Re: Northrop Grumman Comments on Bethpage Remedial Options Report

Comments on Remedial Options Report Regarding the Bethpage Plume

**Northrop Grumman Systems Corporation
Bethpage Facility**

September 9, 2016

1. Cedar Creek Water Pollution Control Plant Treatment Flow Diagram

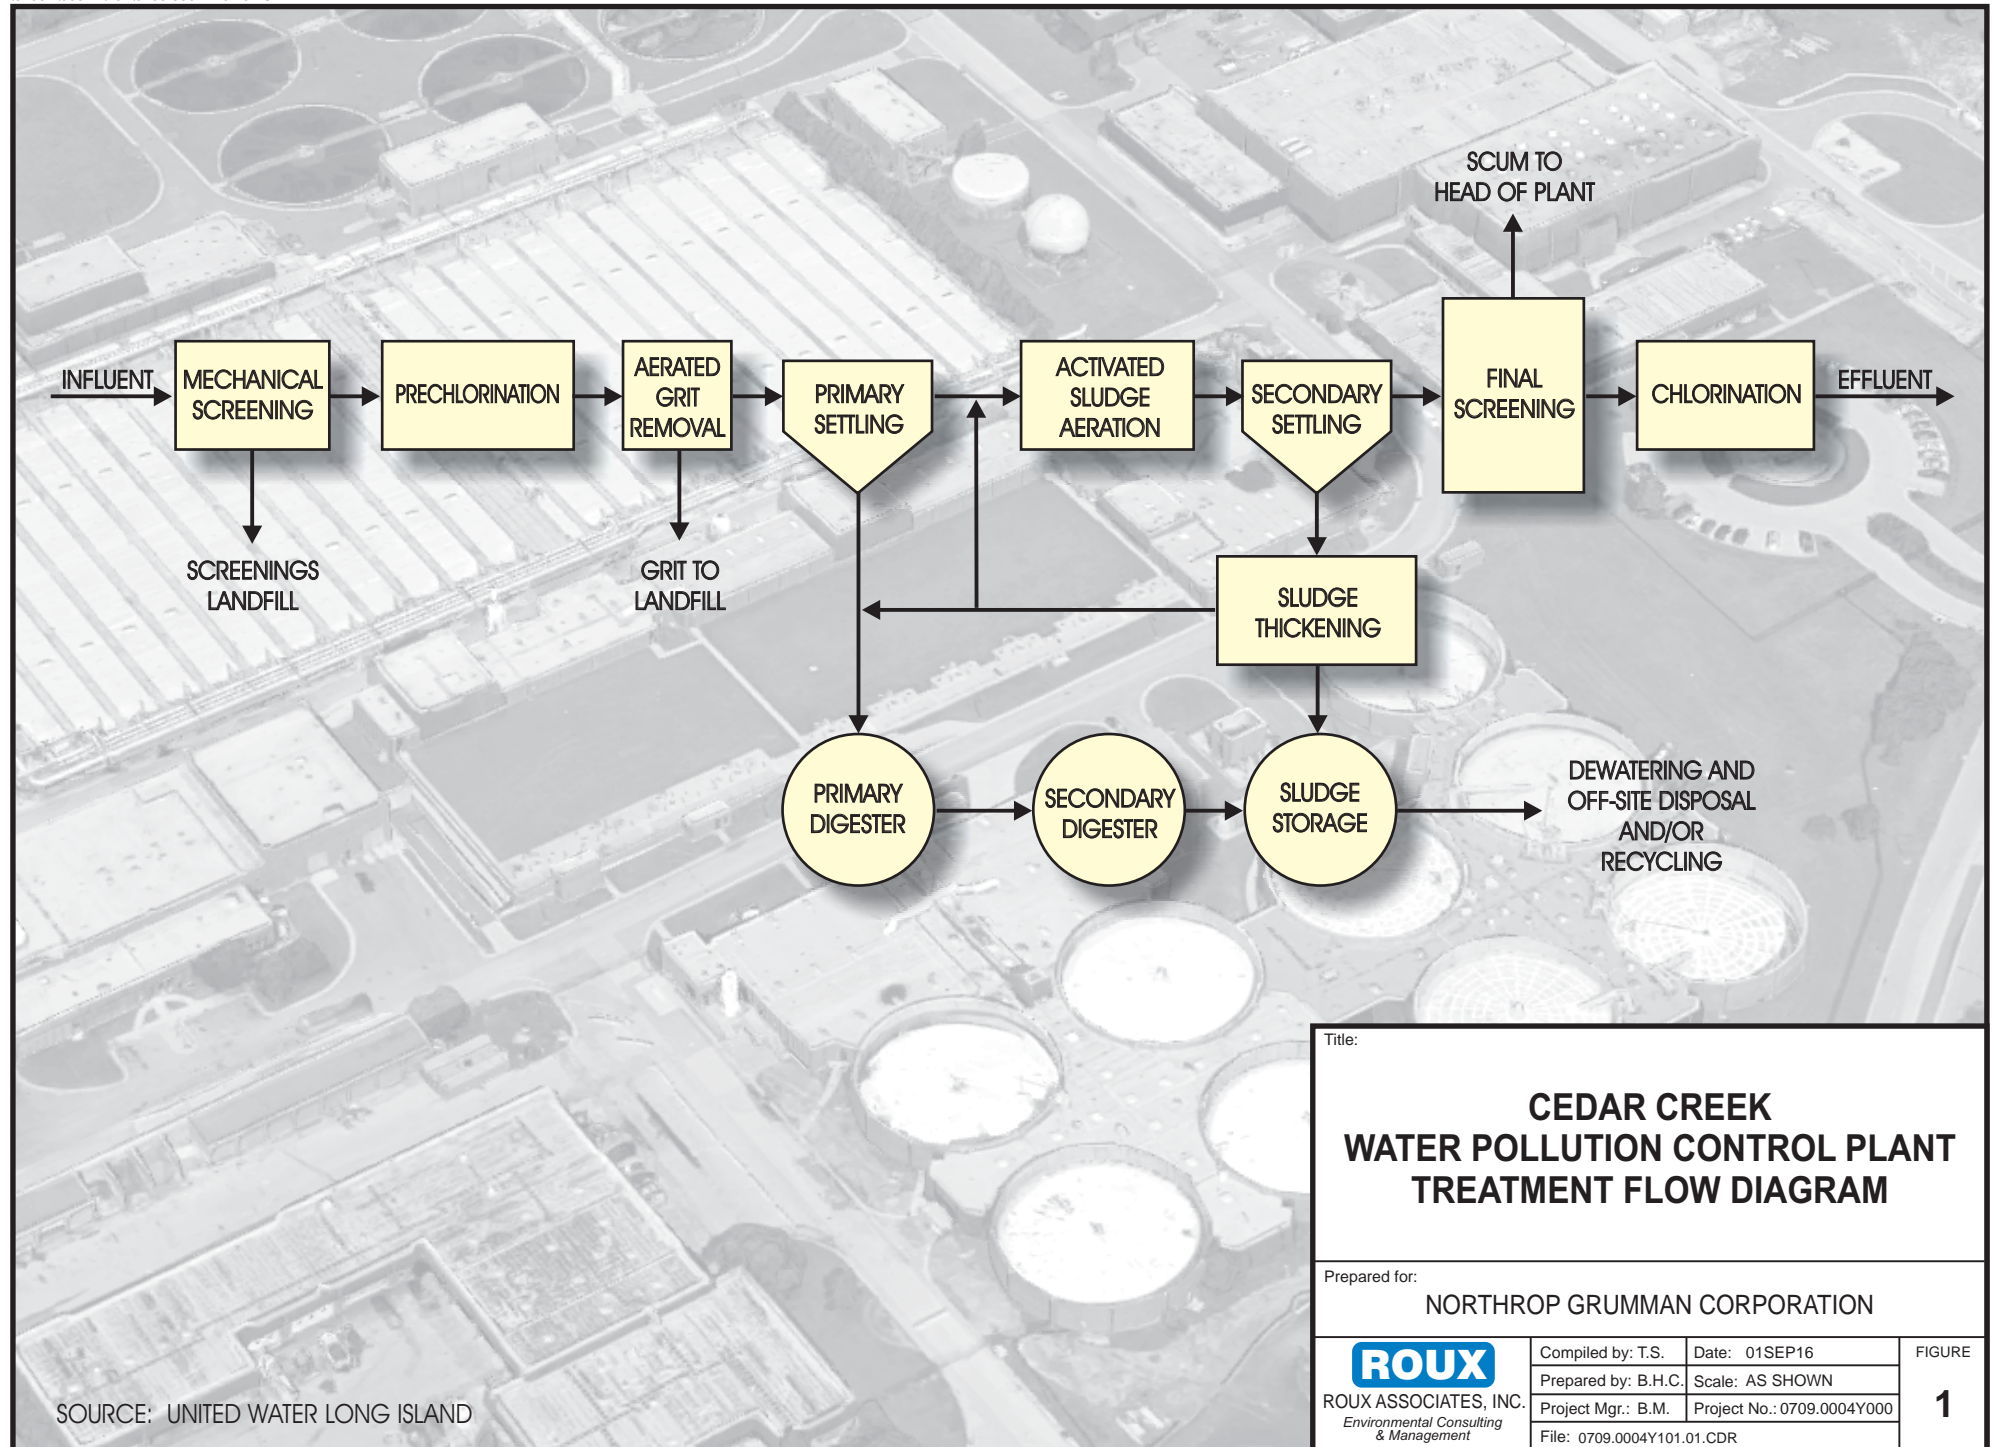
The reason for such restrictions is that the addition of 19 MGD of relatively clean water to the existing influent into Cedar Creek WPCP would reduce the biomass concentration and upset the activated sludge process. This biological process is critical to provide efficient treatment and is dependent on timely development of an adequate biomass of diverse organic matter. This biomass serves as the food supply for the treatment plant’s microorganisms, which drive the degradation of the BOD (organic pollution) and also are useful in removal of fine solids from the wastewater. The addition of large quantities of relatively clean water would slow the formation of floc particles and decrease the settleability of organic material. Operational changes, such as the continuous addition of nutrients and biologic materials could help offset the addition of relatively clean water, but would add substantial complexity and may lead to upset conditions and subsequent SPDES discharge violations due to the discharge of insufficiently treated sewage.
